## **E-Rate FY2022**

# **CATEGORY 2 INTERNAL CONNECTIONS CABLING INFRASTRUCTURE & COMMUNICATION CLOSET UPLIFT**

**RFP # 22-919**

**Site Walk & Questions  
Posted November 23, 2021**

## RCSD Wireless AP Ceiling Tile Installation Preference

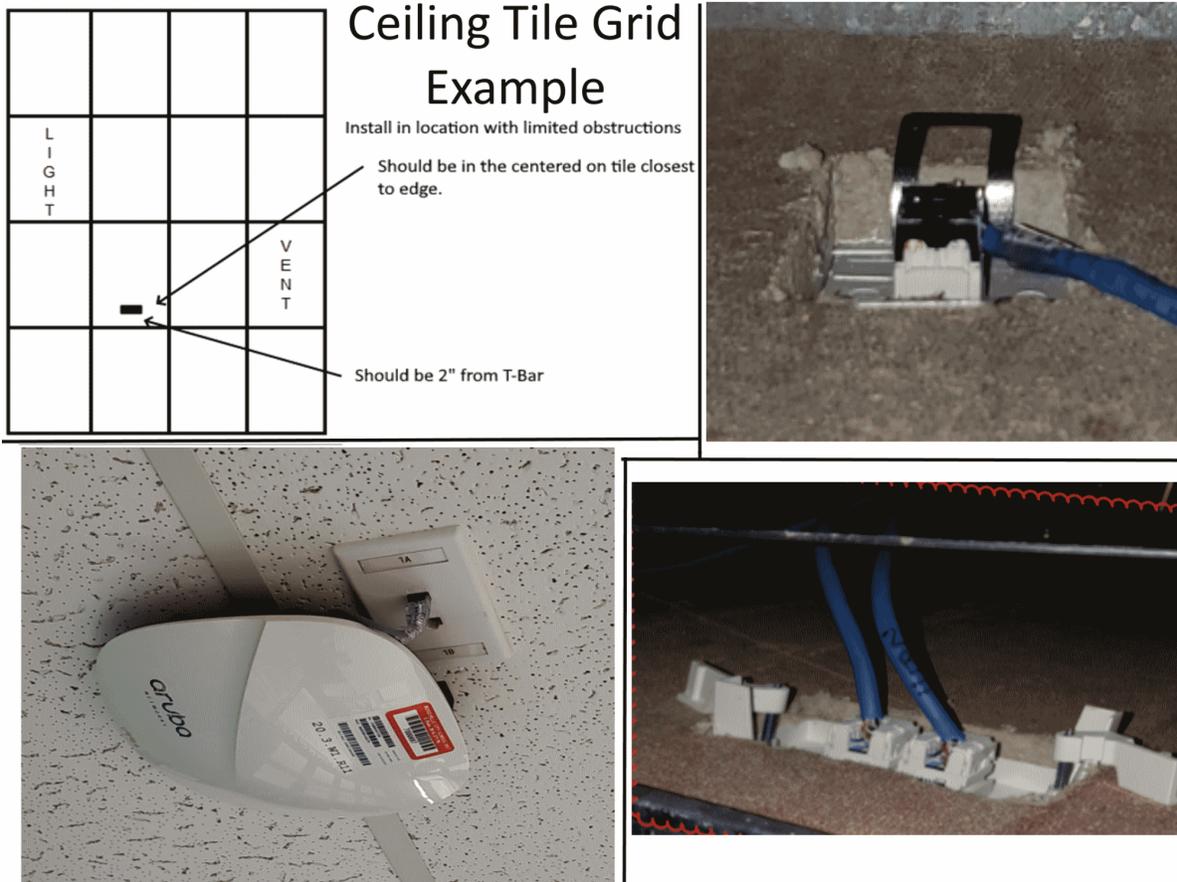
- All WAP installations shall follow District Standard shown below, unless otherwise agreed upon or directed otherwise via the documentation.

## Buljan Middle School

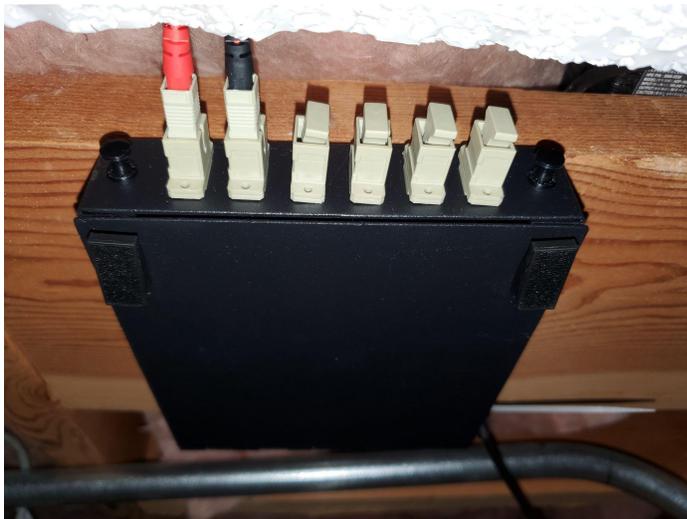
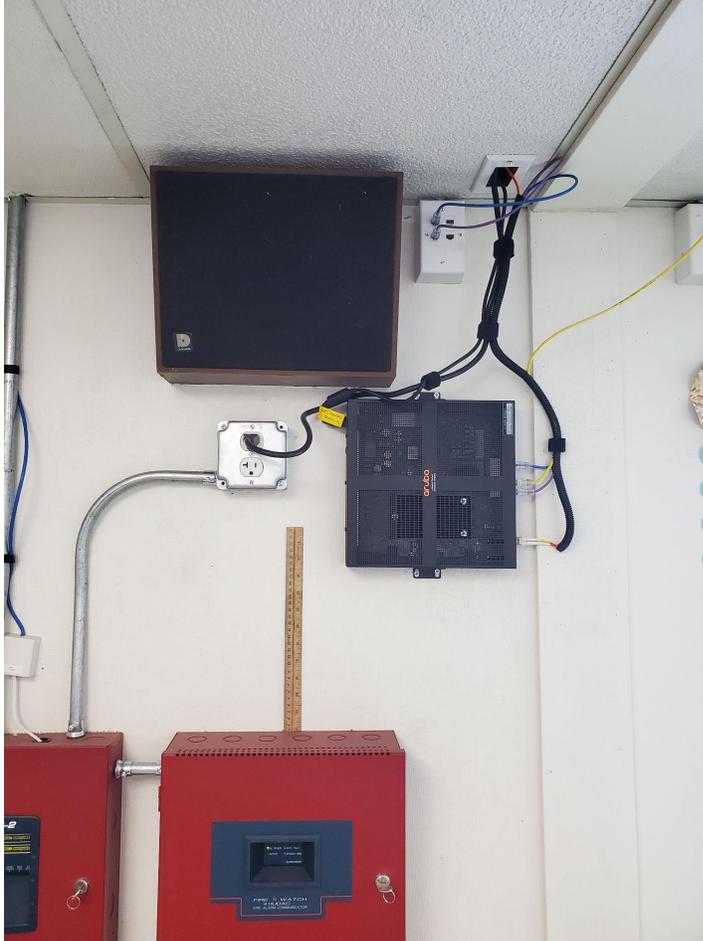
- **On the section for IDF 1.5:**
  - Remove “Install power into cabinet” where referenced. The District will take on all power responsibilities.
  - Revise ‘Install New Cabinet’ to say, Install relocated cabinet from Junction
  - Extend as needed 6 strands from White LIU into new cabinet LIU
- **On the section for IDF 1.3:**
  - No changes to note
